GARVEY COMMONS/ SHERBURNE HALL ADDITIONS & REMODELING
ST. CLOUD STATE UNIVERSITY
ST. CLOUD MINNESOTA

Sheet S-1

ADDENDUM #2, 17 JANUARY 1987, PROJECT 86015
 WAYNE C. LARSON
 STRUCTURAL ENGINEERS
 2129 2ND STREET
 WHITE BEAR, MN 55110
 612/429-8363

PARTIAL FOUND. & FLOOR PLAN - SHERBURNE HALL SCALE 1/8" = 1'-0"

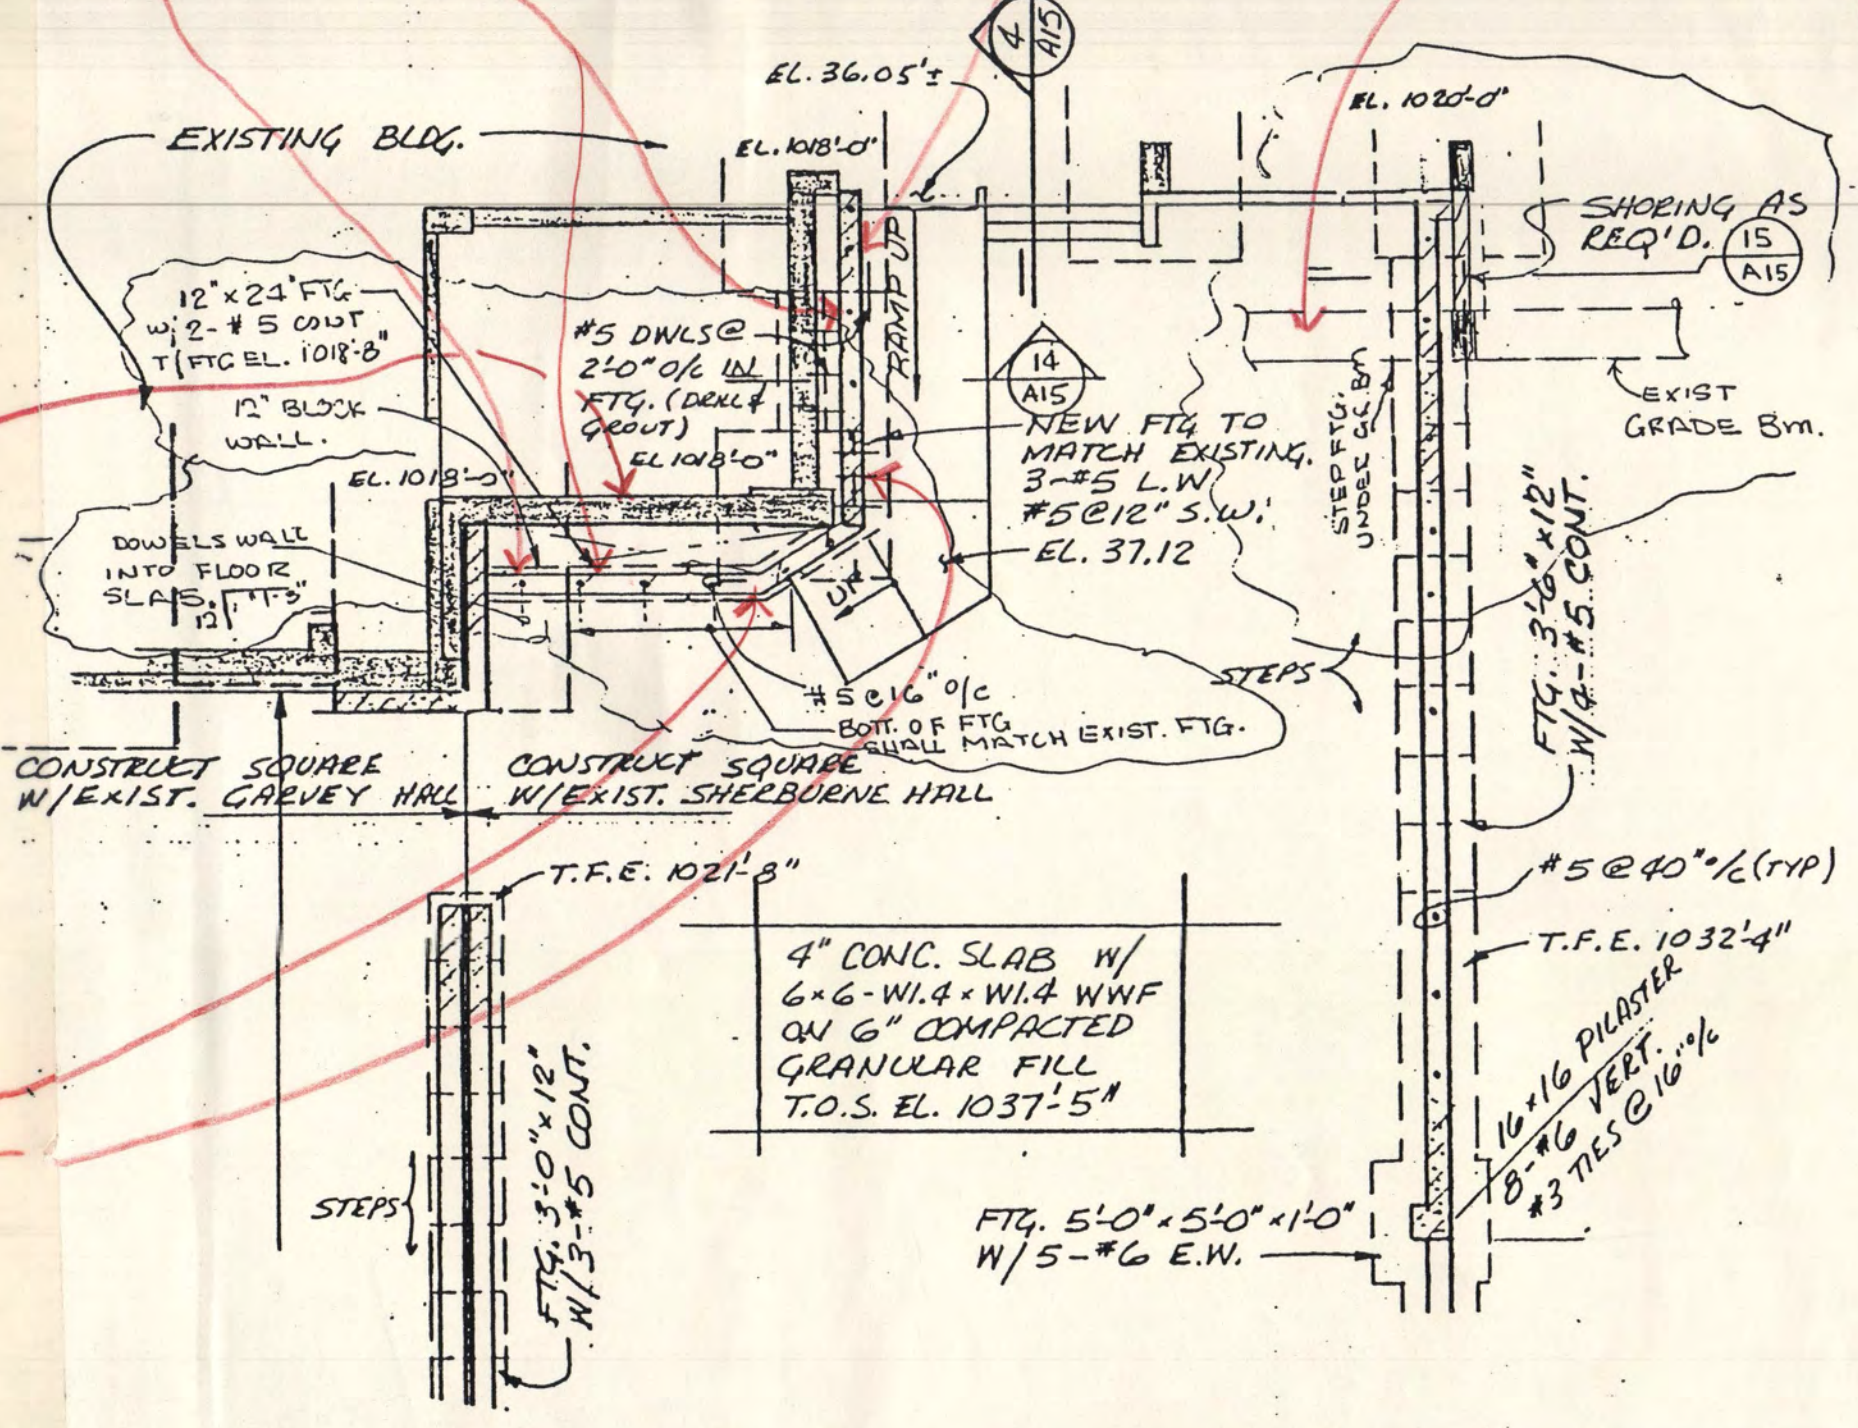
- 135. See revised "partial foundation and first floor plan" and "partial roof plan".
- 136. Add note on roof plan. "See mechanical and architectural drawings for locations of roof opening".
- 137. Details 1 and 3: See A-sheets for proper location of pilasters and concrete beam at north wall window opening.
- 138. Detail 3: Change the bottom of beam elevation to 1047'-3" and precast plank bearing elevation to 1048'-5".

FOUNDATION & FLOOR PLAN - LOUNGE AREA SCALE 1/8" = 1'-0"

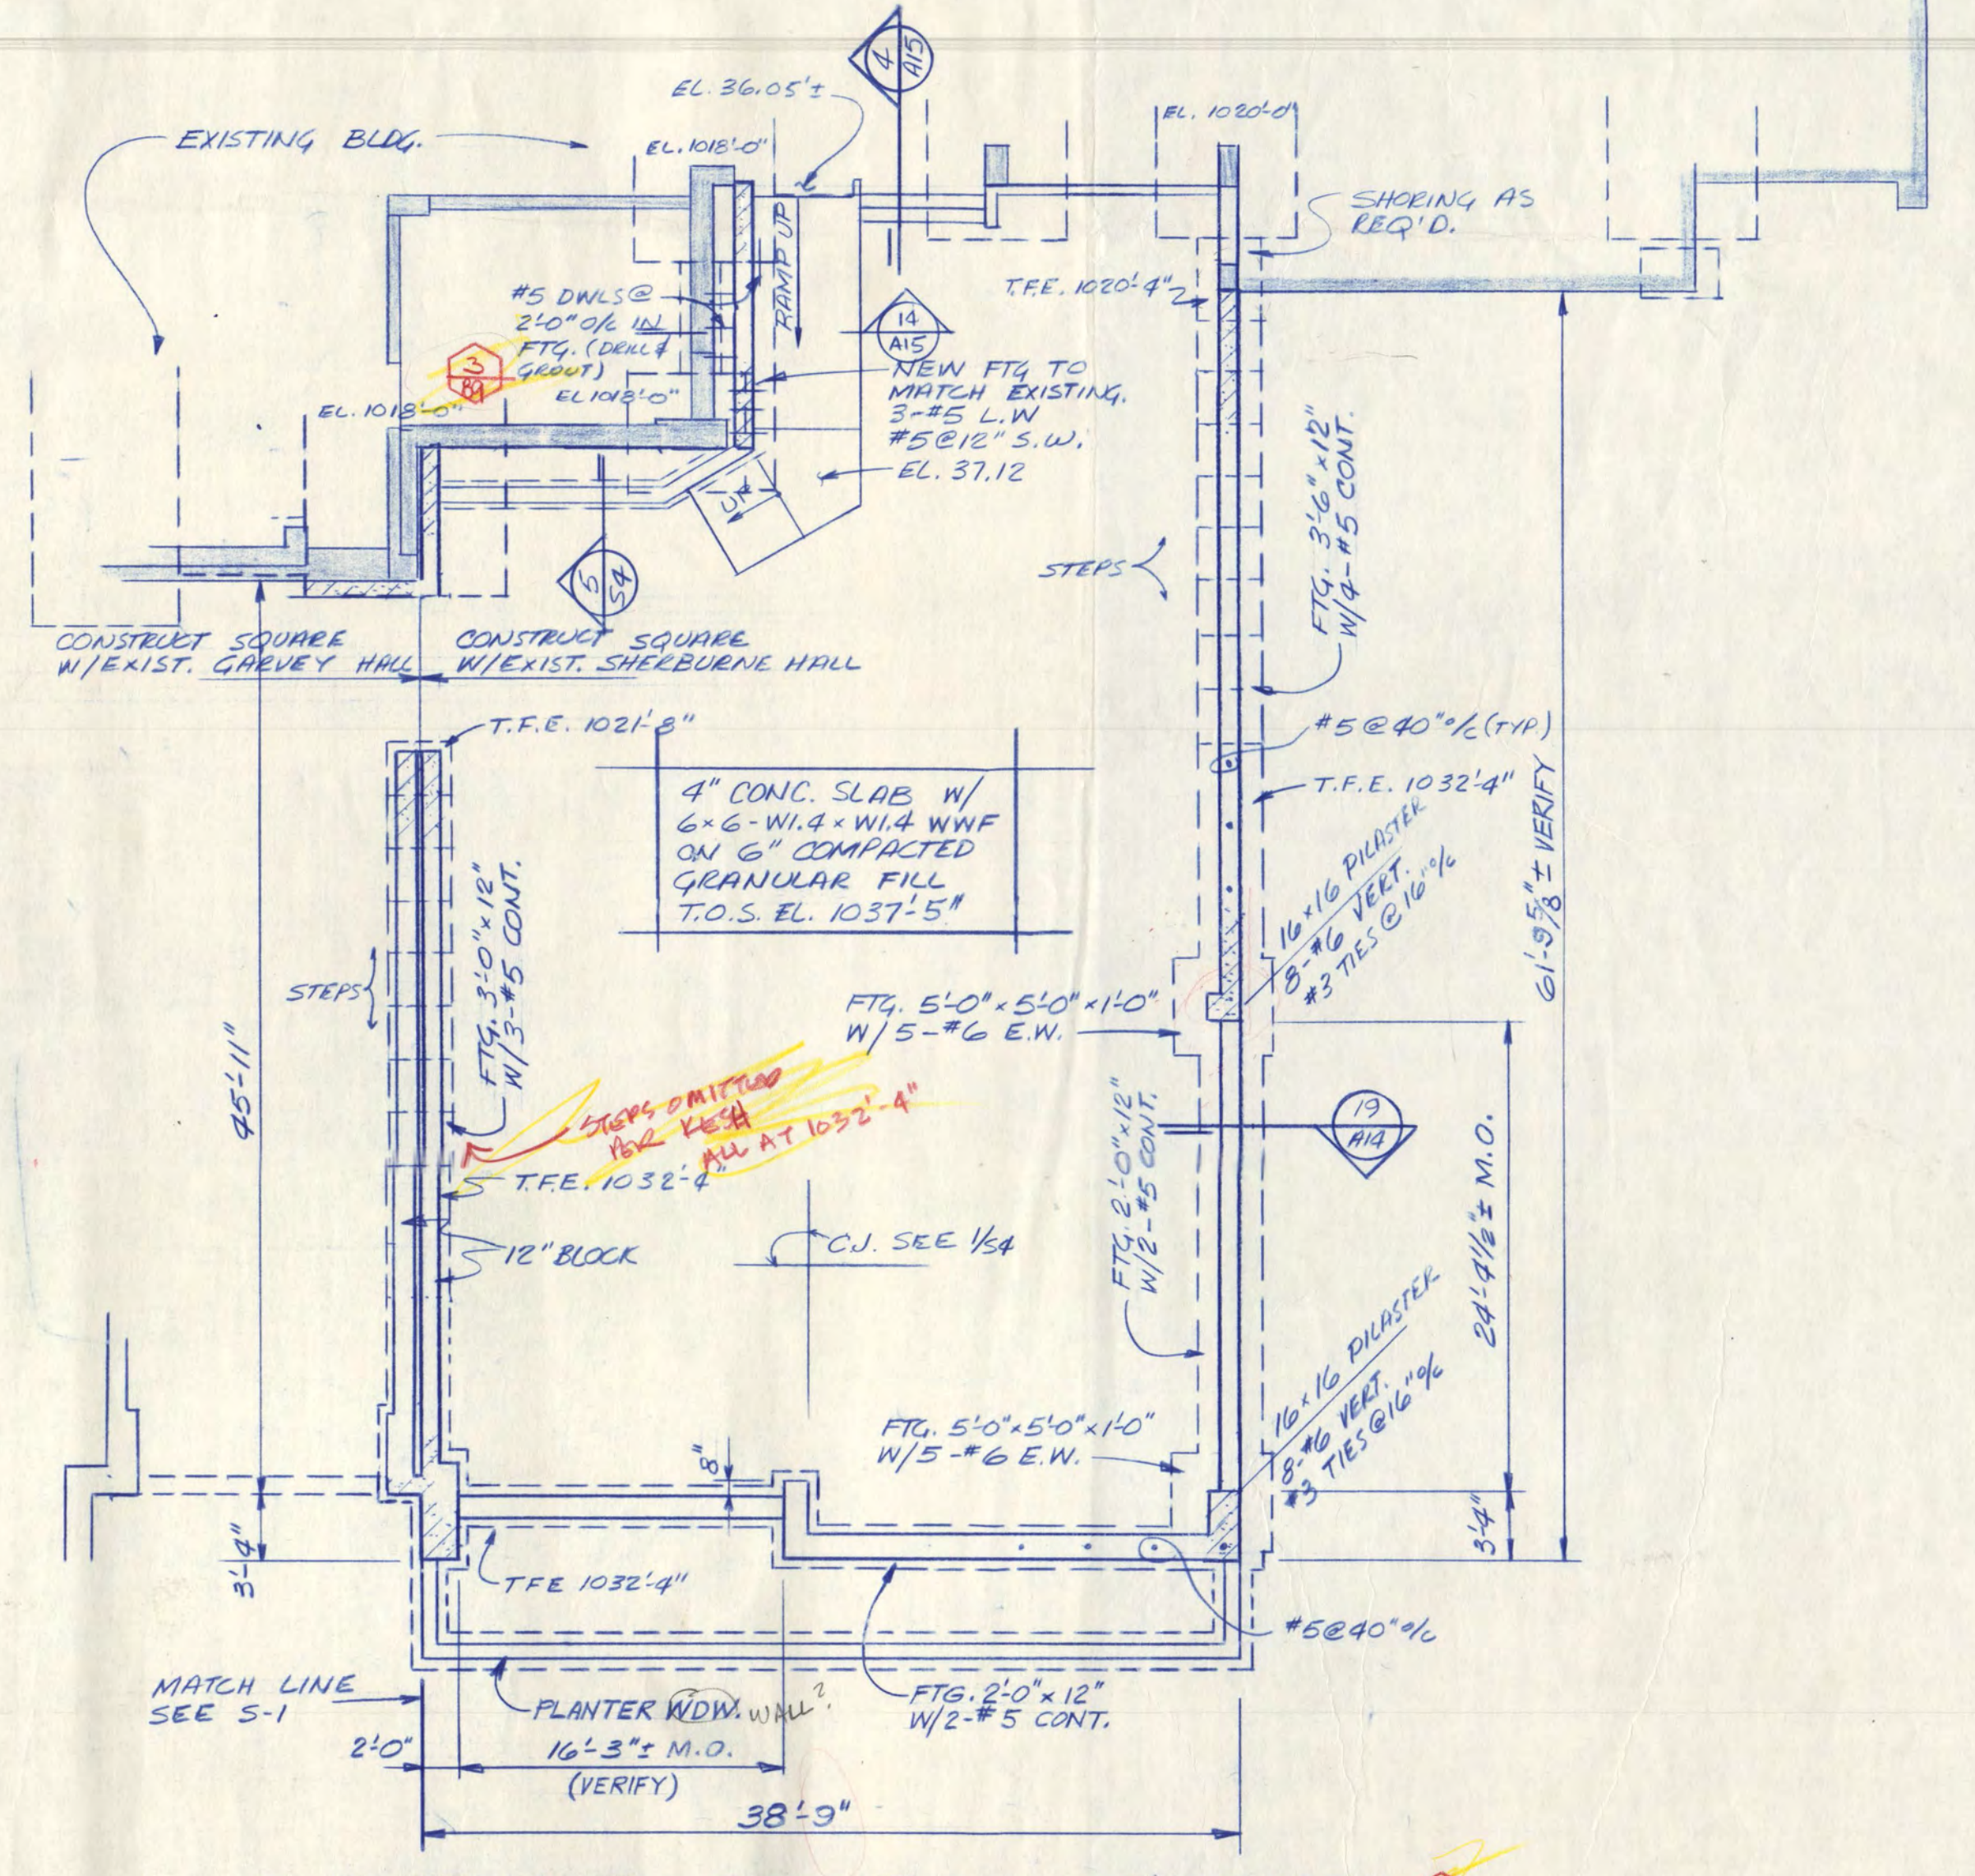
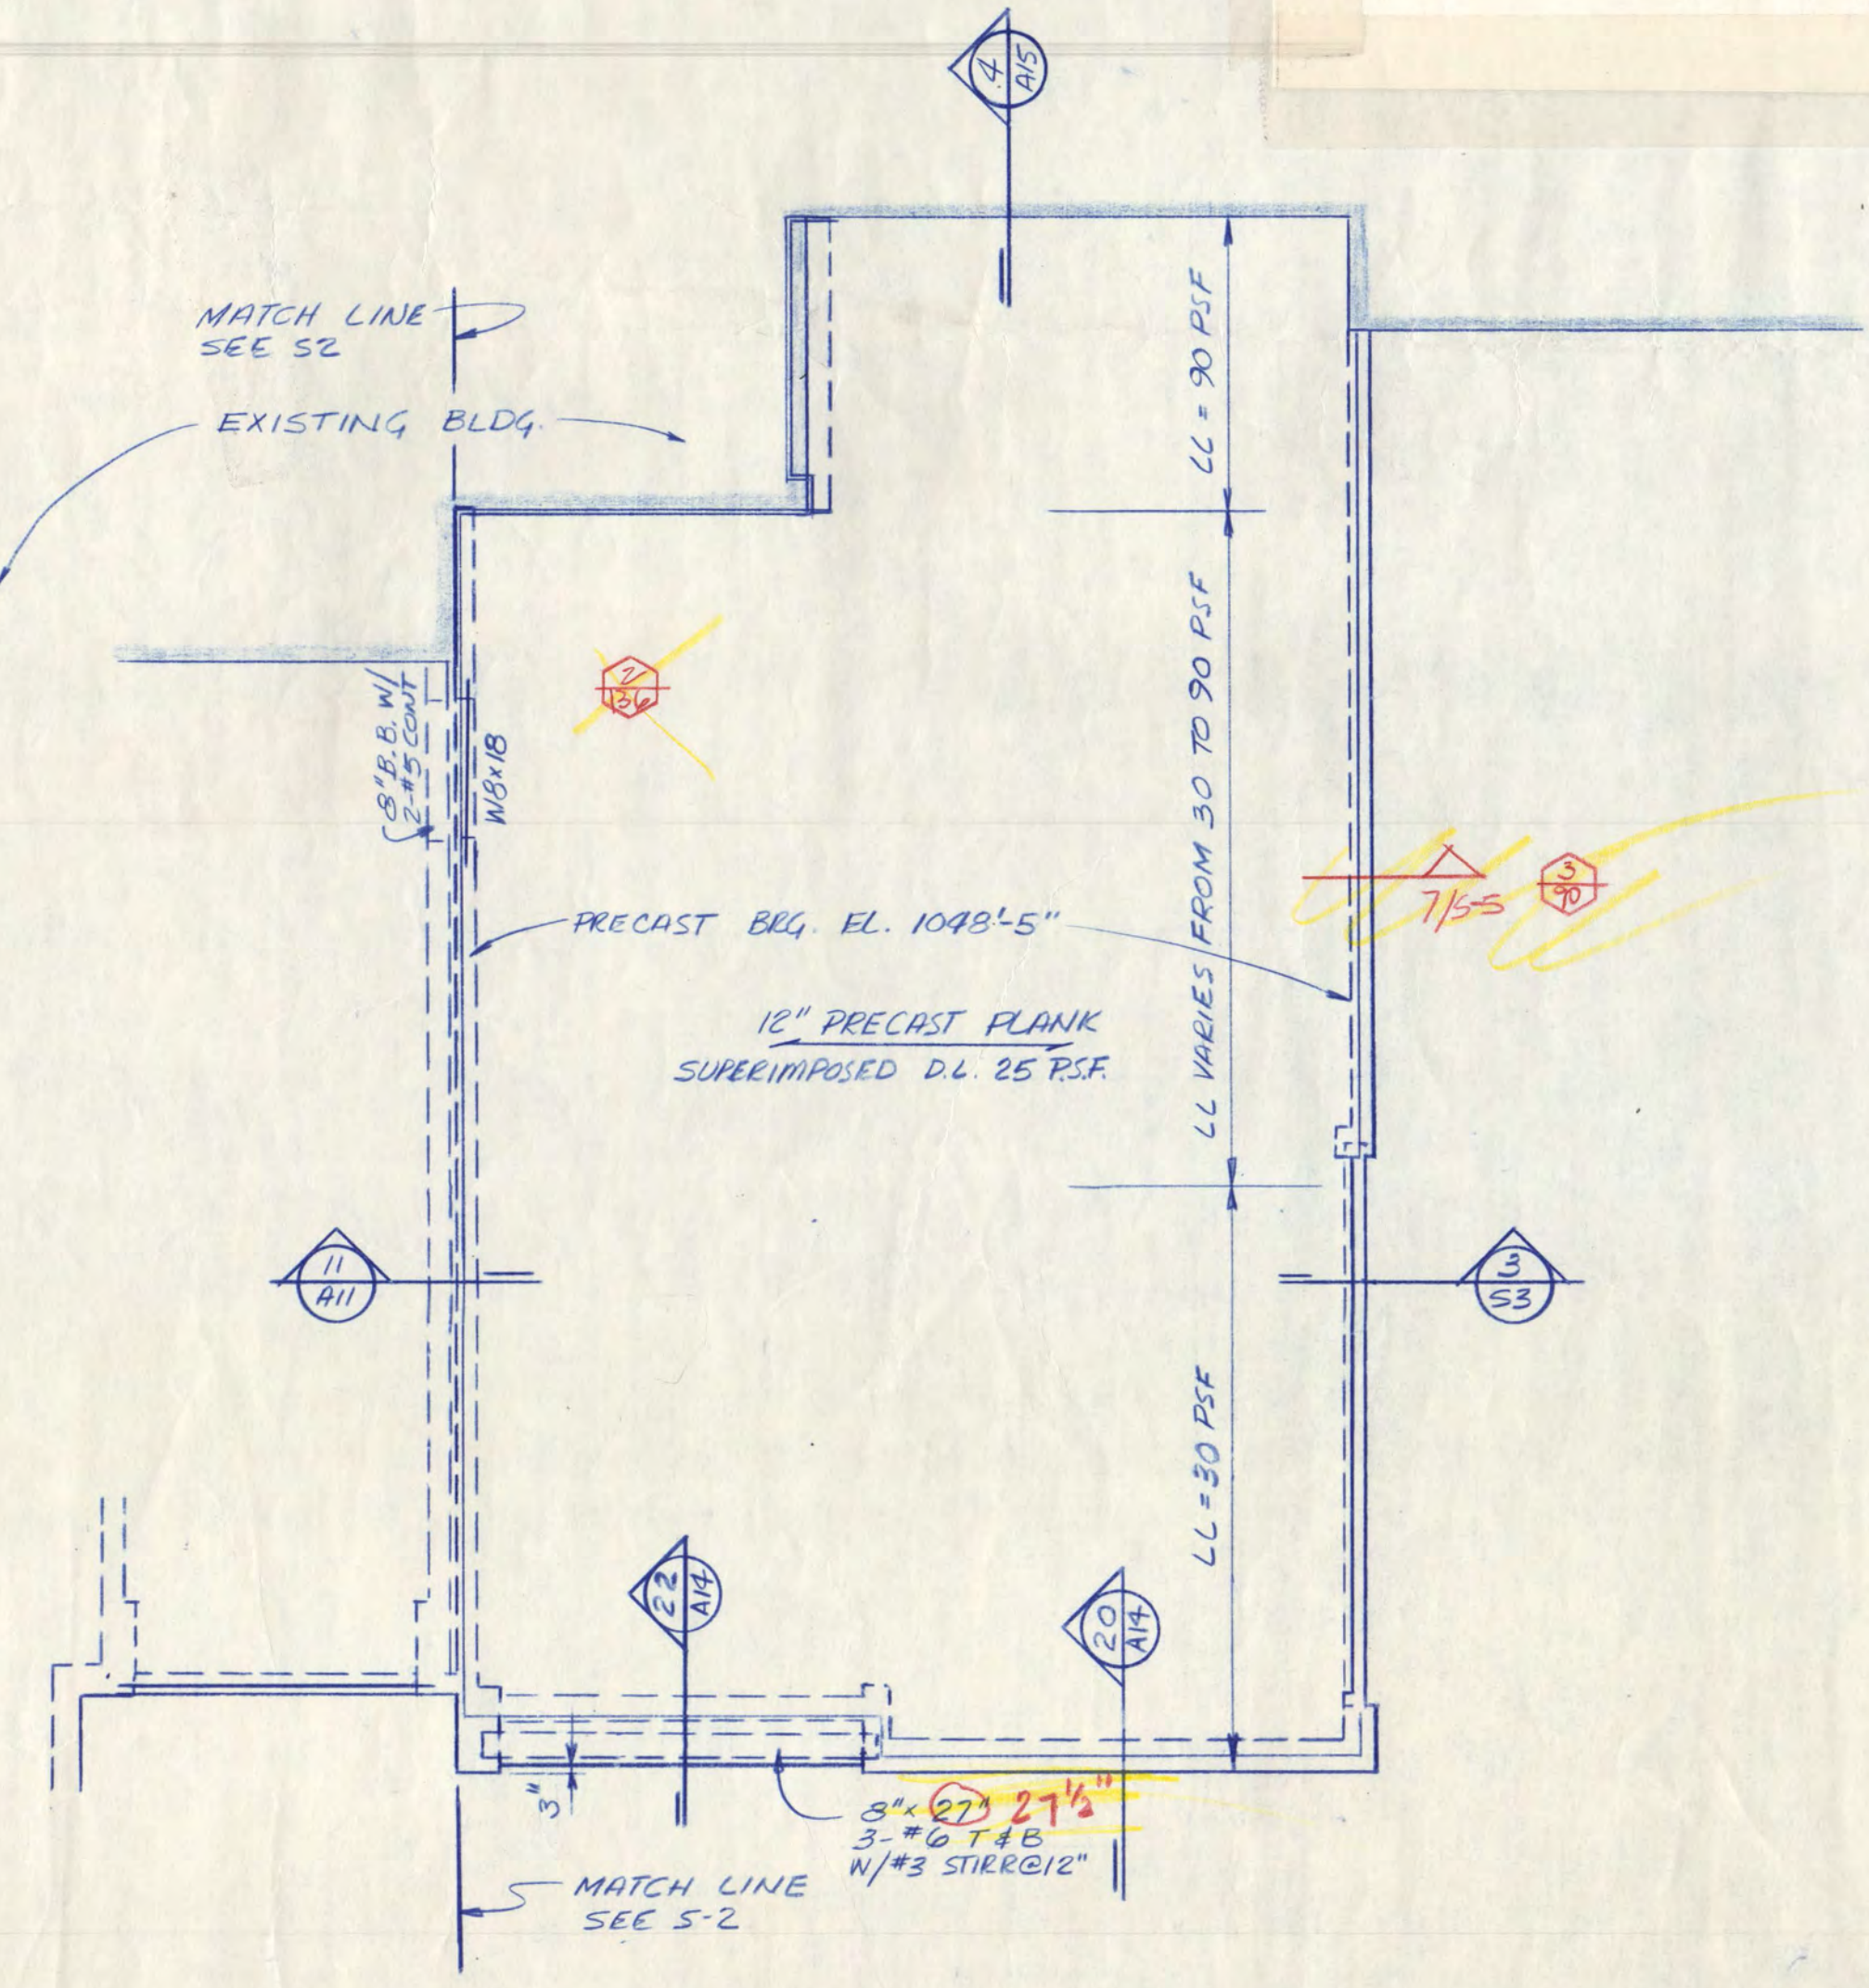
- 89. Detail 1: Connections between new and existing walls is per detail on 3/5-4.
 - 90. Detail 2: Add section cut 7/5-5 on north wall.
 - 91. Detail 3: Connection between precast plank and concrete beam is similar to Detail 3/5-5.
 - 92. Detail 3: All weld plates are 4" x 4" x 1/2" plate with two 5/8" diam. x 6" studs.
- Weld plates and connecting angles are by Section 0550; installed by Section 0330.
